Colgate University
Merrill House Parking Lot & Hamilton Street Driveway Realignment
Date: January 13, 2025

Addendum No. 1

Bid Documents Dated December 18, 2024

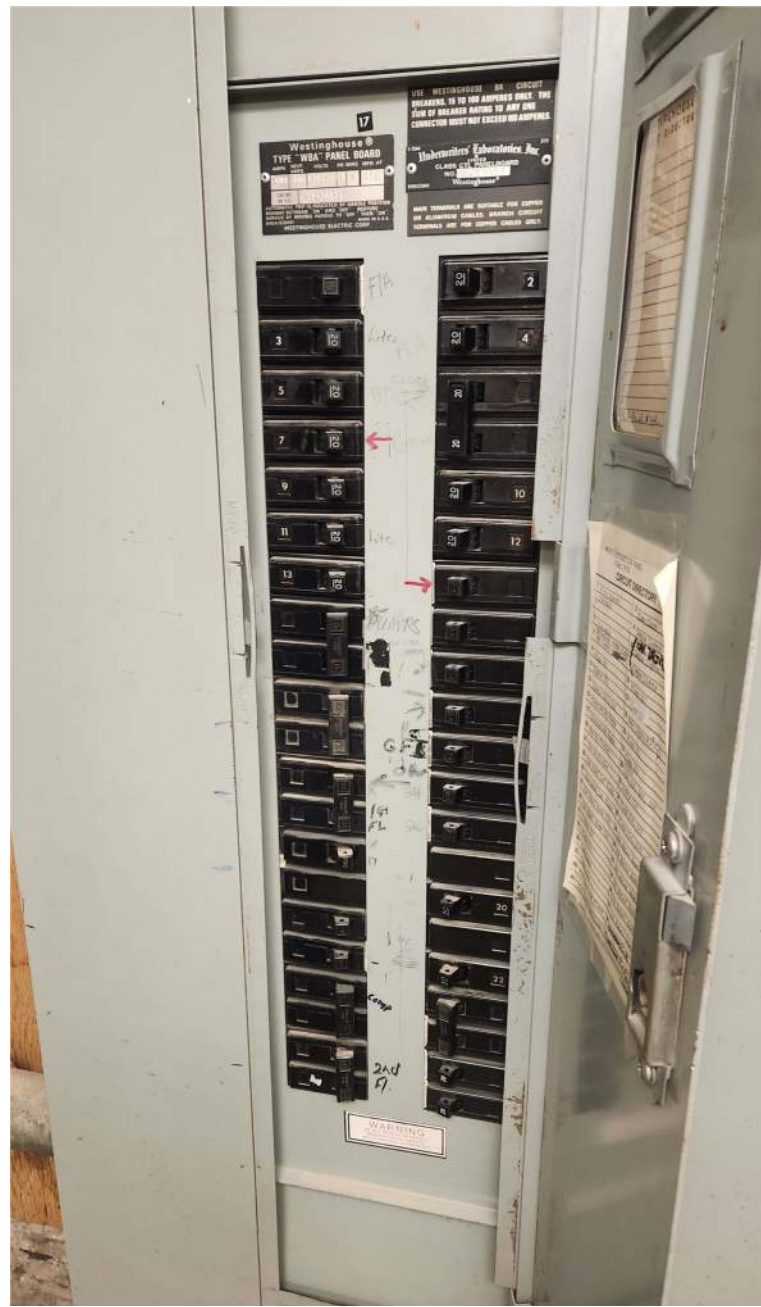
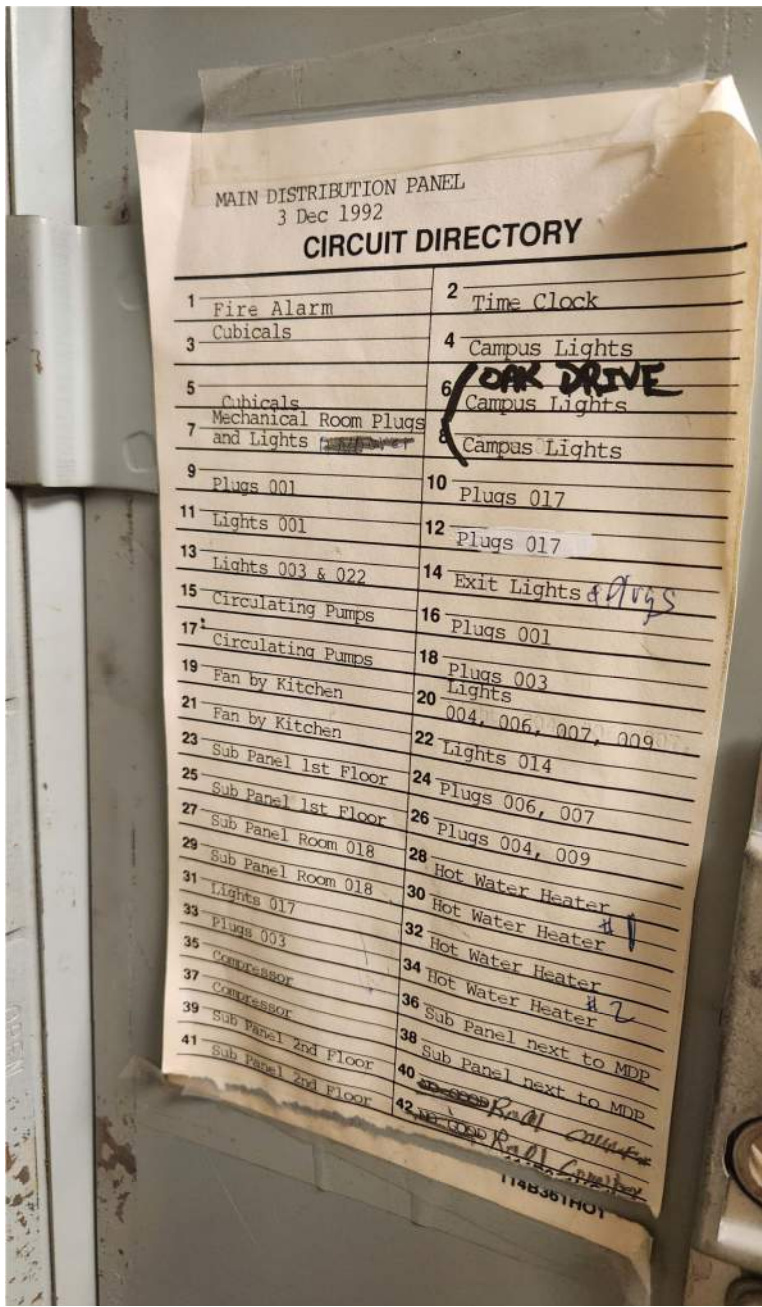
Interior view north basement wall.
Due to electric panel and meter locations, it is assumed that secondary service enters the basement above finish grade. Contractor must provide all materials and labor to replace secondary service and repair building and framing in-kind.

Main panel inside Merrill House conference room electrical closet. Circuit directory is full.

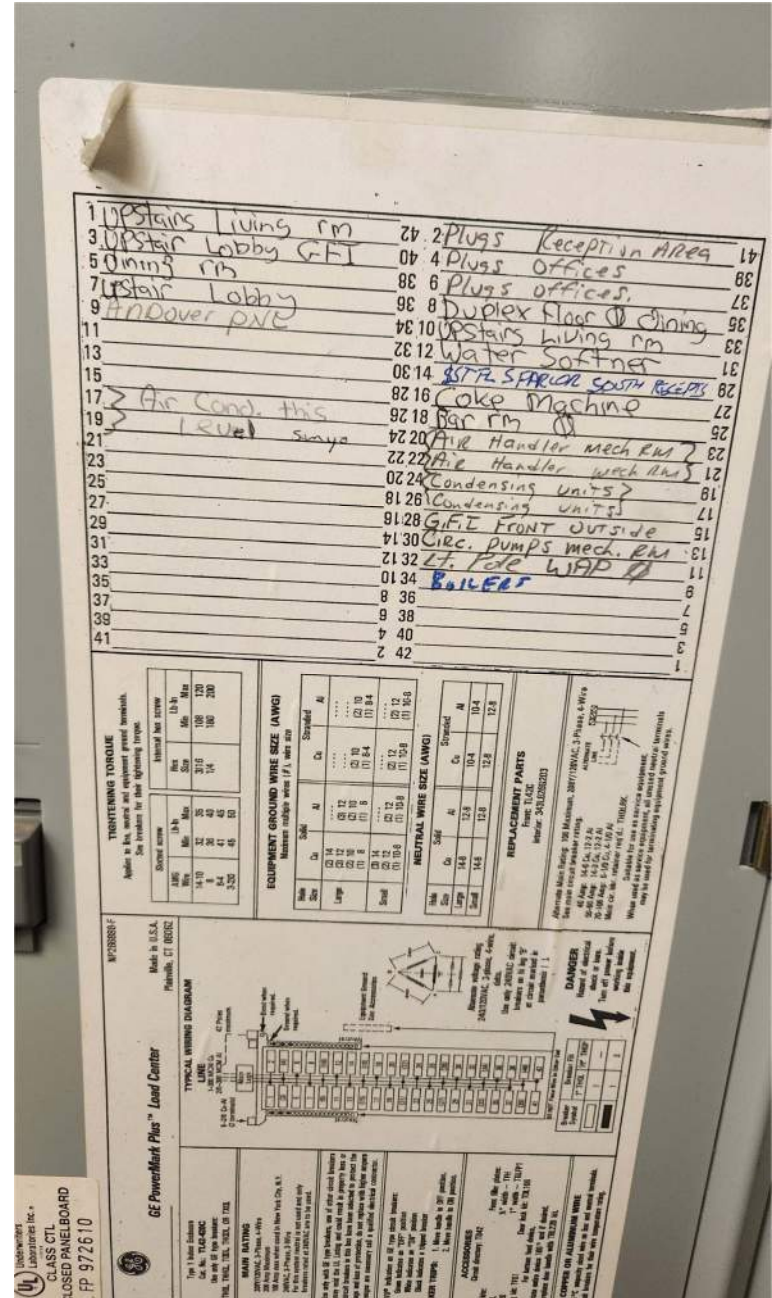
Secondary panel inside Merrill House conference room electrical closet. Secondary panel has space for additional circuits, but existing contactor is full. Contractor must provide all materials and labor to provide fully functional site lighting system.
